Re: Proposed Rule - Siting (10 CFR Part 100)
F.R. October 30, 1992

RESPONSES TO COMMISSION QUESTIONS ON
PROPOSED REVISIONS TO
REACTOR SITING CRITERIA (NONSEISMIC)
RE: PROPOSED REVISIONS TO 10 CFR PART 100
F.R. OCTOBER 20, 1992

FIGURE 4

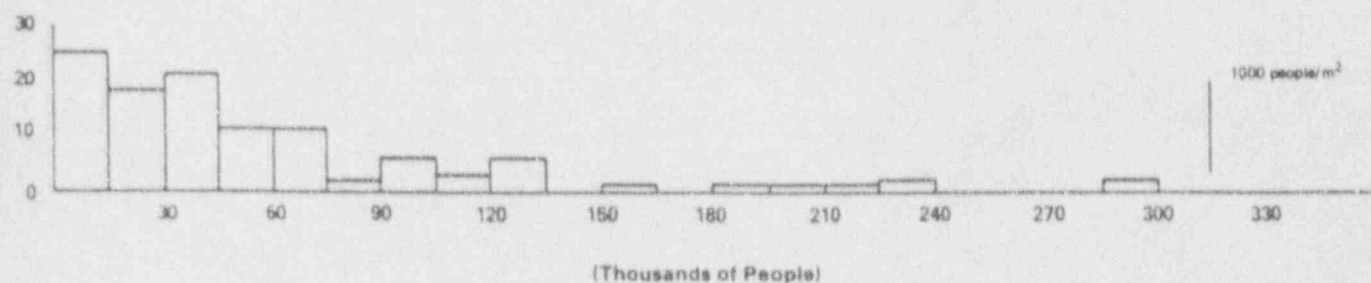
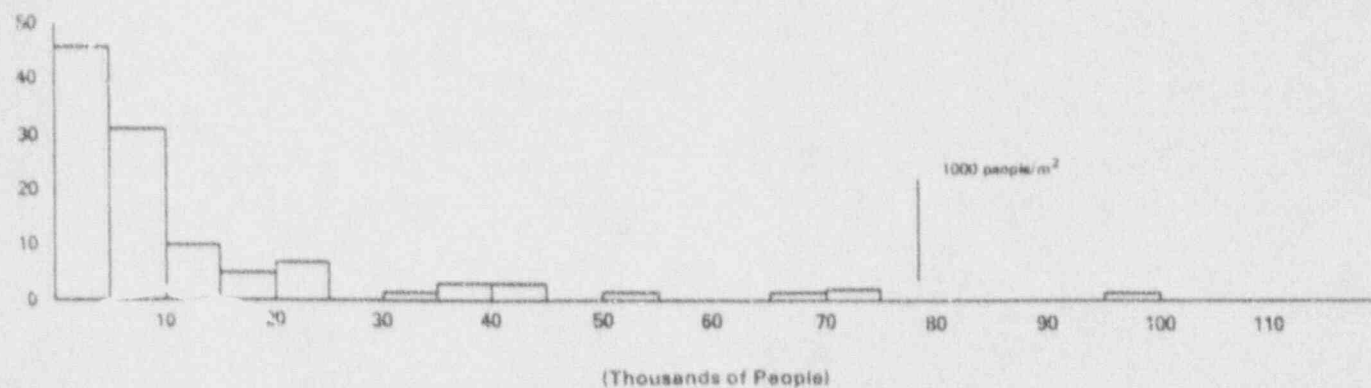
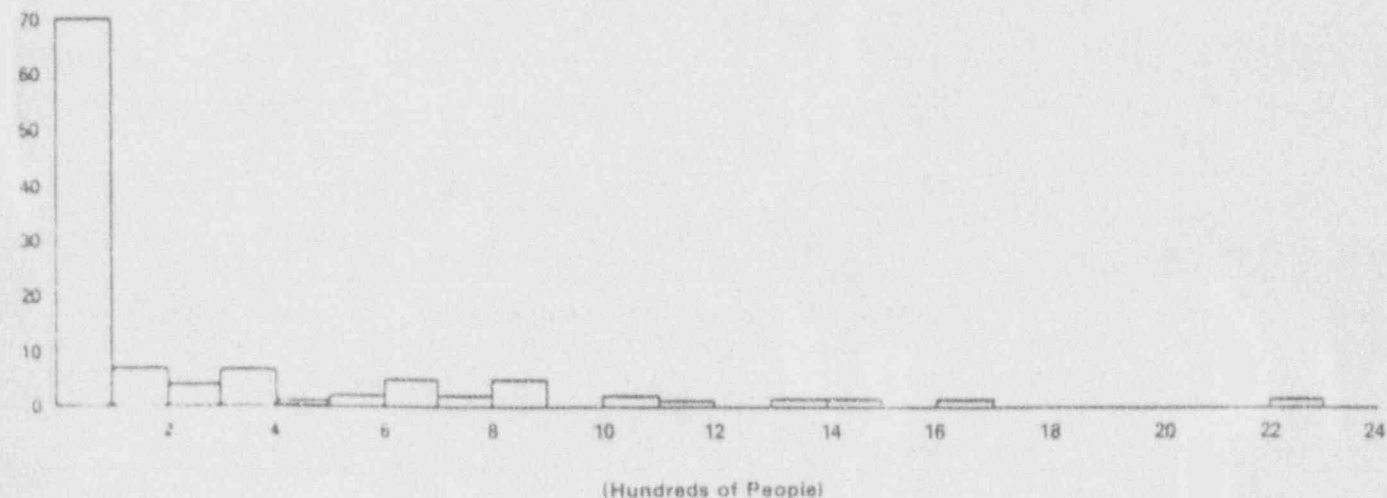
RESPONSE: This depends on the objective(s). Assuming (further) that the Commission would no longer approve certain current higher density sites, it could peruse the graphs in NUREG-0348, "Demographic Statistics Pertaining to Nuclear Power Reactor Sites", select those it would outlaw in the future, and pick the number that falls out. Figure 4 of NUREG-0348 is attached as an example.
